1. Call to Order
2. Approval of Minutes of Previous Meeting
 - Minutes of 5-2-2024
3. Old Business
4. New Business
 - BSCBA26-A-01; Signature Homes; Appeal of International Residential Code R405.1 regarding foundation drainage at 3020 Beringer Circle
5. Public Comment
6. Other
7. Adjournment

Meeting: Building Safety Code Board of Appeals
From: Michael Frank, Building Inspector
Nicholas Hanson, Building Official
Date: August 18, 2026
Subject: 3020 Beringer

Question Before the Board

Is a filter membrane required to be installed?

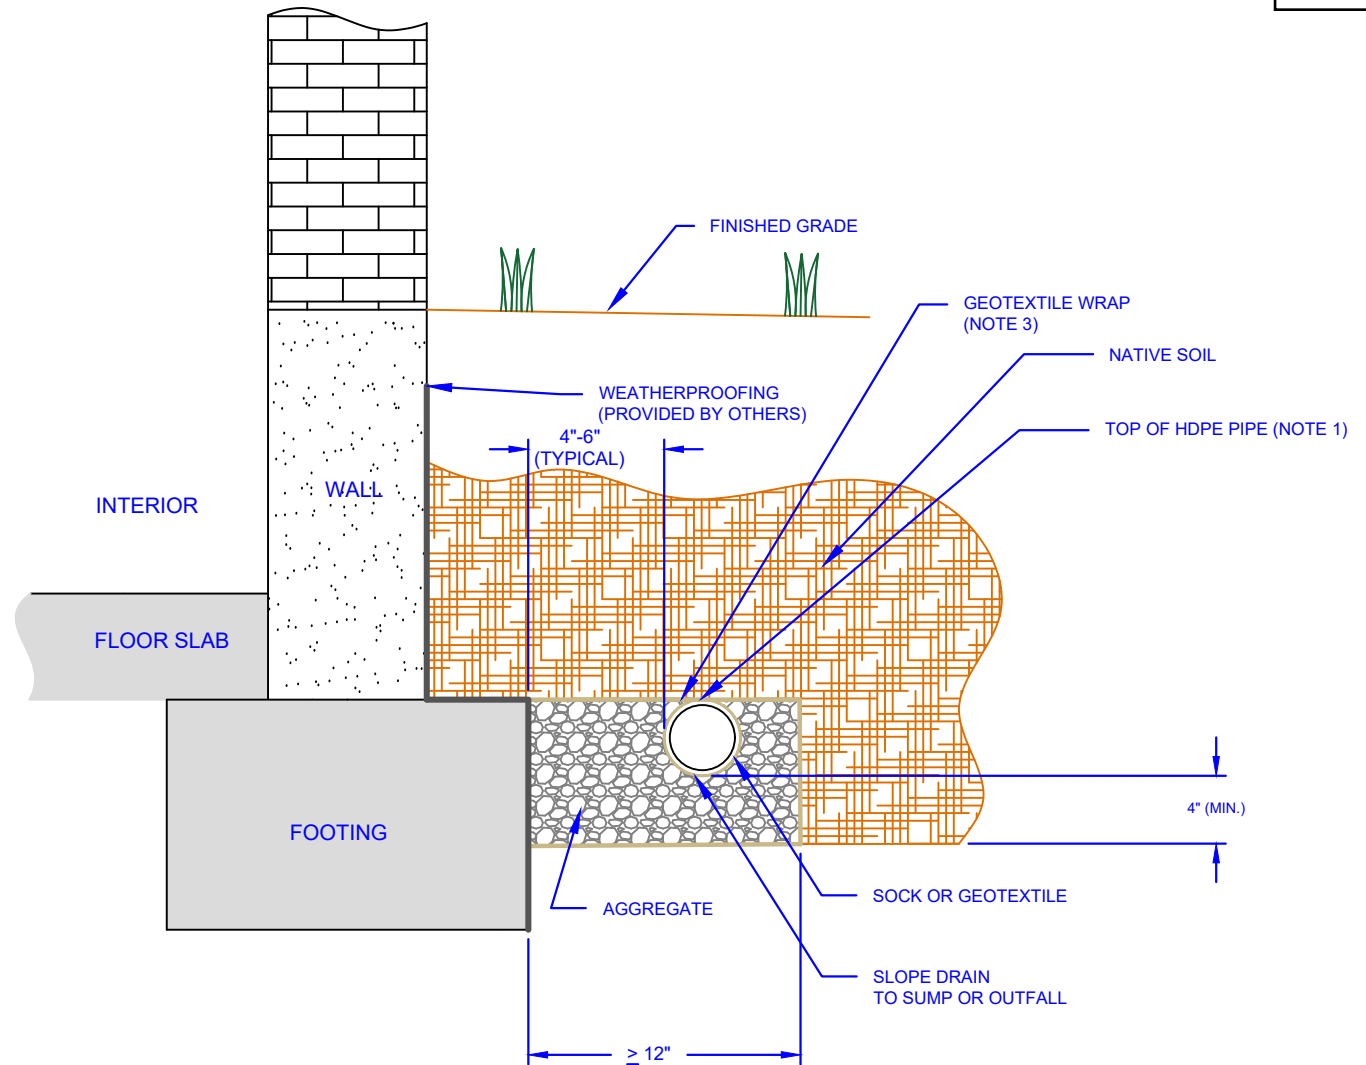
Thank you for taking the time to discuss the tile that Prinsco offers. We have a contractor who has installed a foundation drain both inside the house and around the perimeter like this:

The tile in question is the one with the red arrow pointed at it. From the wording of the code, this needs an approved filter membrane around the tile or above the rock, and the commentary on this section of code states the reason for this membrane is "The filter membrane allows water to pass through the perimeter drain tiles or pipes without allowing, or at least greatly reducing, the possibility of fine soils entering the drainage system"

Our question is whether Prinsco, as the drain manufacturer, would have a structural engineer sign off on the installation of the tile on a basement foundation, confirming that it meets or exceeds the minimum code requirements outlined in R405.1 of the 2021 International

Good morning Abby,
To answer Michael's question, we are unable to sign off on installations.

Since we are the manufacturer of the pipe, we can provide product specifications and installation recommendations. However, verifying that an installation complies with local requirements is outside our scope. Determining whether an installation meets standards and approving it remains the responsibility of the Engineer of Record (EOR).

Existing Foundation Drainage

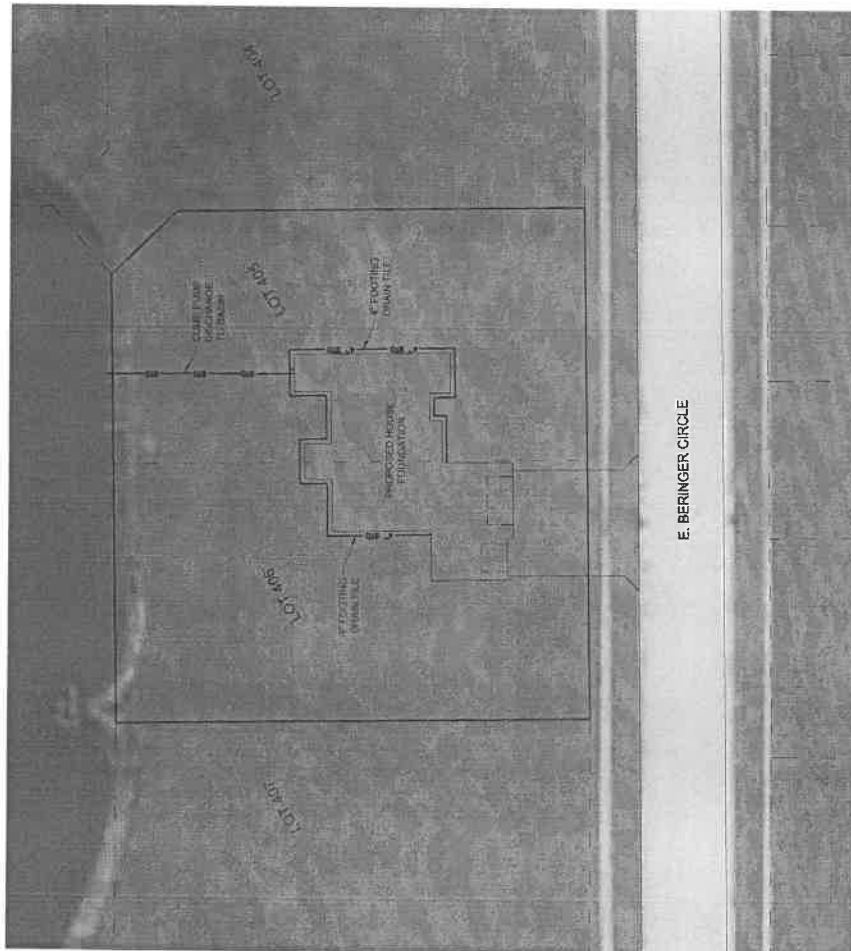
- we have a drainage tile system installed on both the exterior AND the interior, that has been approved by a professional engineer
- see detail attached that has been approved and stamped by a licensed professional engineer

The code calls for perforated drains to be surrounded with an approved filter membrane, or the filter membrane shall cover the washed gravel or crushed rock covering the drain, except where otherwise recommended by the drain manufacturer.

- Our drain tile manufacturer has published the exact drain tile detail on their website that we have currently installed at the property
- see link to website and detail below
 - [Applications - Prinsco, Inc](#)

In summary, we believe our foundation drain tile system is completely within what is required by the building code, and we should be permitted to continue with the final inspection of the property.
